Special Bulletin

SP21-82A

Revision: A. Seats removal operation added, screw holes drilling + labor time adjustment. 03-20-2023

FLOOR SIDE FLAT BAR

FIGURE 1

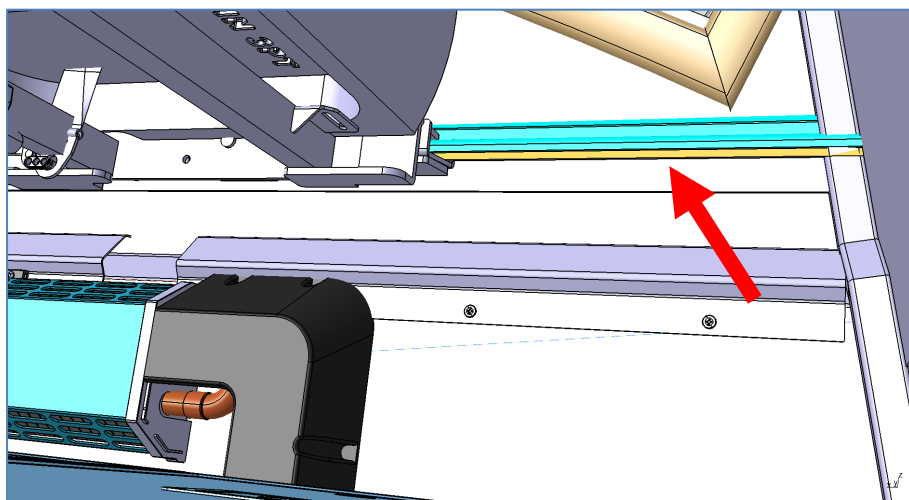
1. Remove the passenger's seats.
2. Install a flat bar (P/N: 24144641) on the linoleum top end.

FIGURE 2

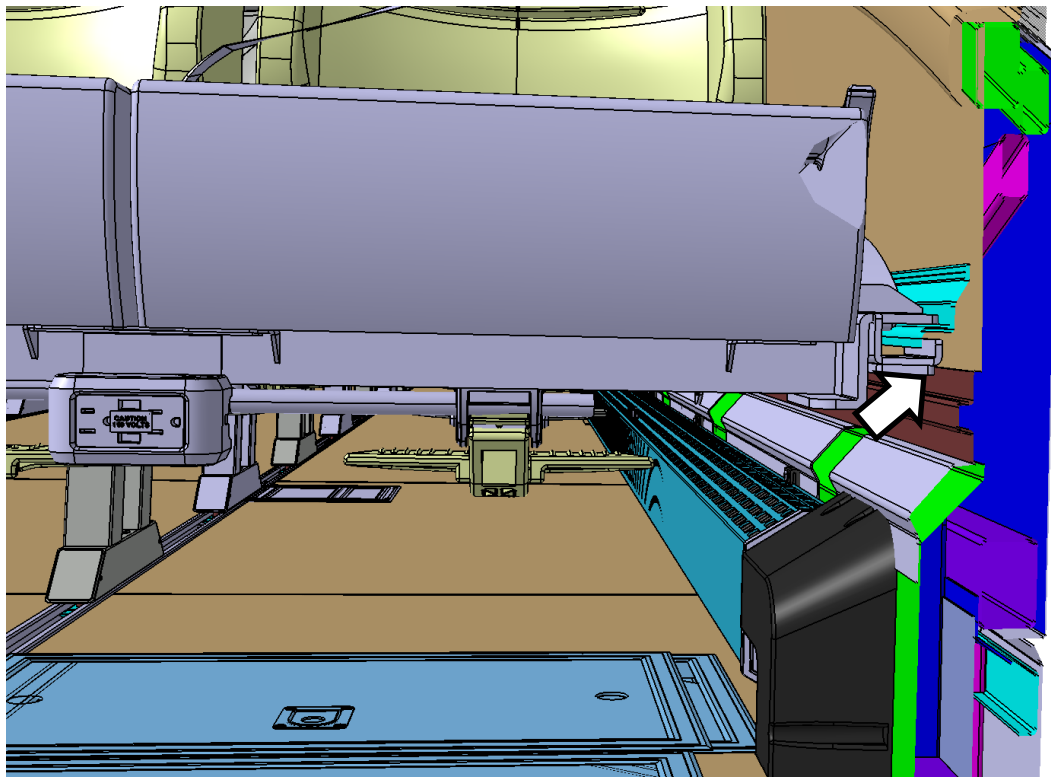
3. Location of the flat bars (*P/N: 24144641*) along the side wall is behind to seat rail aluminum profile.

FIGURE 3

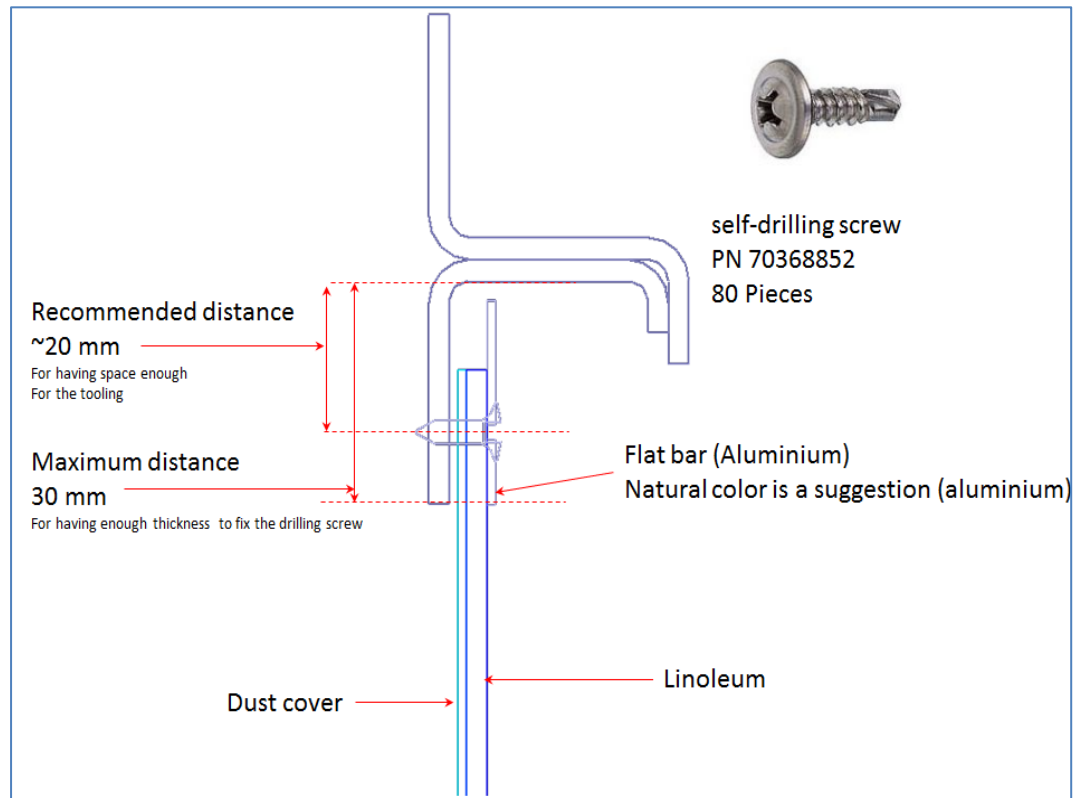
Each flat bar should be screwed using a CROSS RECESSED SUNK SCREW (*P/N: 70368852*) according to dimensions recommended at **FIGURE 3**.

Each flat bar contains 4 drilling guides. Secure the flat bar with 4 CROSS RECESSED SUNK SCREW.

NOTE: Pre-drill the flat bar sunk screw positions using a 3/16" drill bit.

FIGURE 5 FLAT BARS INSTALLATION AT THE RIGHT-HAND SIDE.

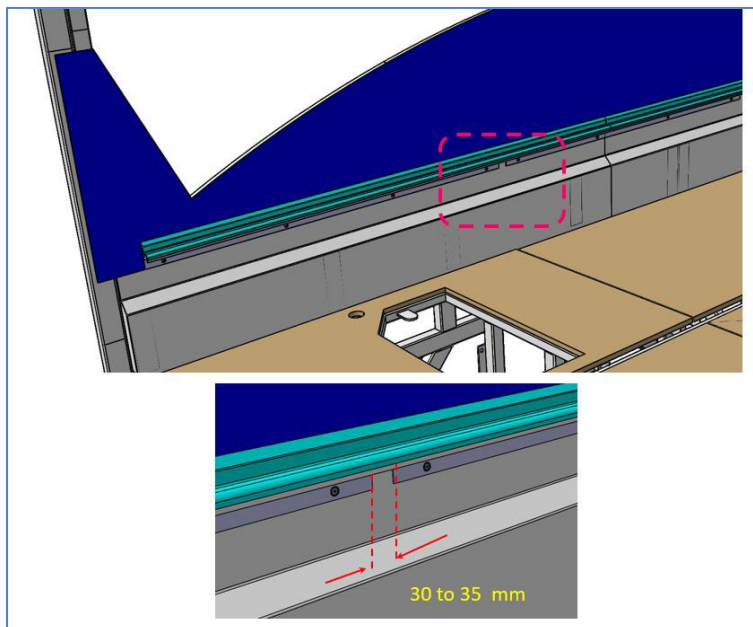
For the right side, the separation between each flat bar should be **30 - 35 mm** (Figure 5).

The reason for these suggested separations is to span the entire length under the side rail.

FIGURE 6 FLAT BARS INSTALLATION AT THE LEFT-HAND SIDE.

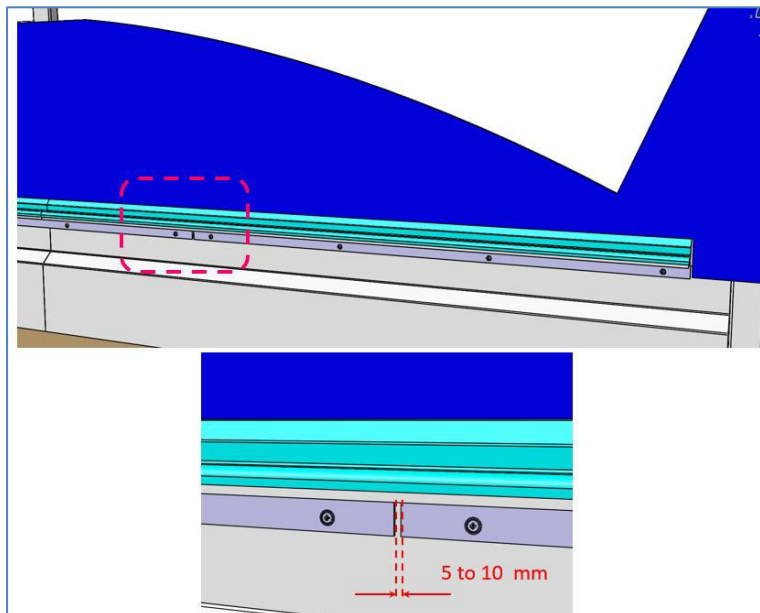
Note: Consider a separation of **5-10 mm** (Figure 6) between them of on the left side for a better distribution of the supports along the bus.

Figure 9

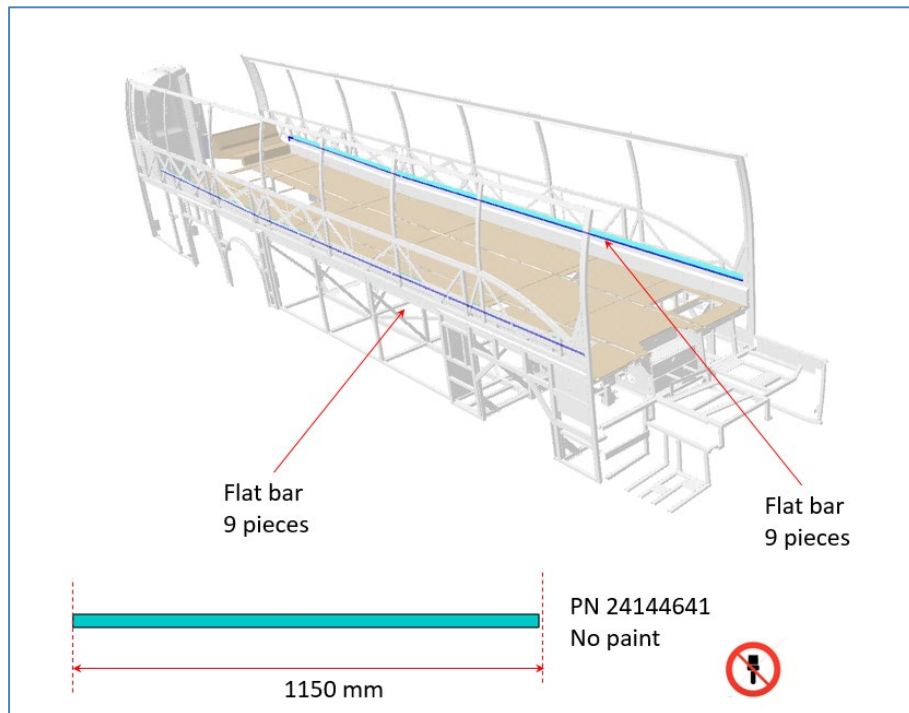
5. An additional molding (*P/N: 24144661*) will be added (*only for the back corner, on the left side*) to improve the quality of the finish.

The additional molding should be screwed as shown at the **FIGURE 9** using 4 CROSS RECESSED SUNK SCREW (*P/N: 70368852*).
